ECE/TRANS/WP.29/2010/23
18 December 2009

Proposal for Supplement 5 to the 04 series of amendments to Regulation No. 48
(Installation of lighting and light-signalling devices)

Submitted by the Working Party on Lighting and Light-Signalling */

VISIBILITY OF CONSPICUITY MARKINGS TO THE REAR, FRONT AND
SIDE OF A VEHICLE

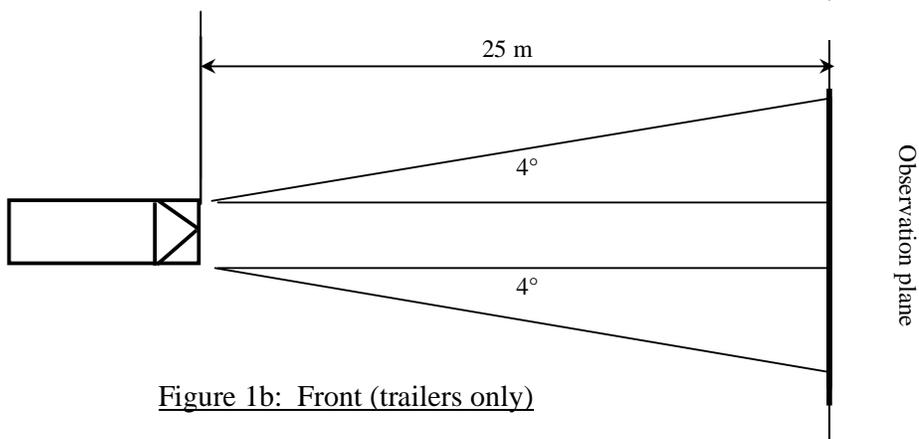
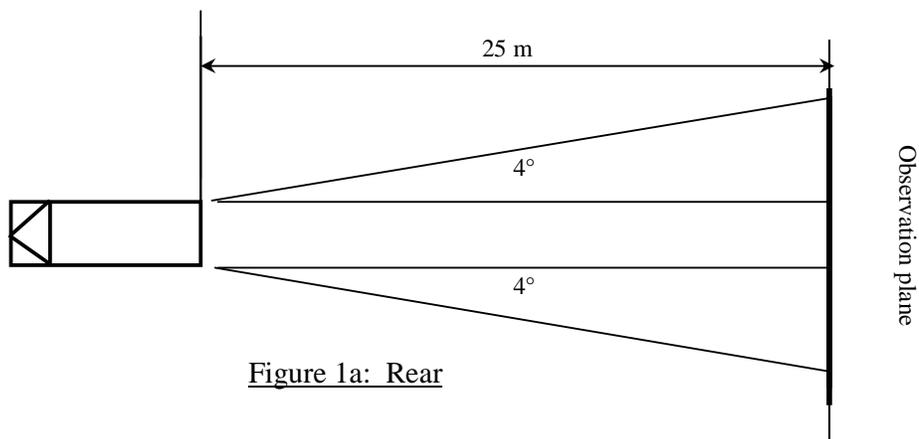
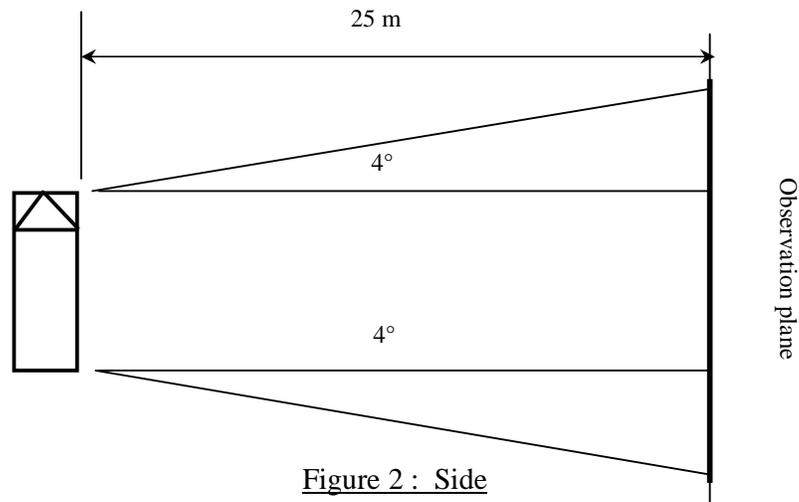
"6.21.5.1. for rear and front conspicuity markings (see Annex 11, Figures 1a and 1b) the observation plane is perpendicular to the longitudinal axis of the vehicle situated 25 m from the extreme end of the vehicle and bounded by:"

Annex 11, amend to read:
